U Series (06/08)

Noticed date: 3-DEC-2025

Affected products: U Serie for port size 3/4", 1" Filter Regulator Lubricator

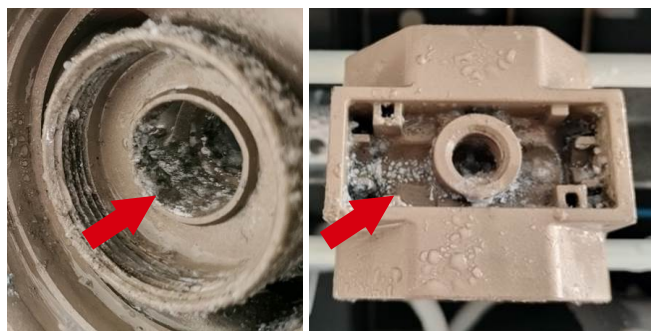
Change details: a. Baking paint was changed to an electrophoretic coating
b. The champagne gold color has been changed to black

Change reasons: Improve product corrosion resistance

BODY (Baking paint) - 48 Hours

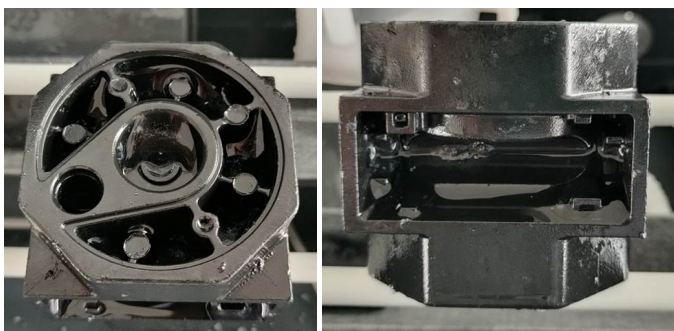
The results of the salt spray test are as follows:

BODY (Electrophoretic coating) - 48 Hours
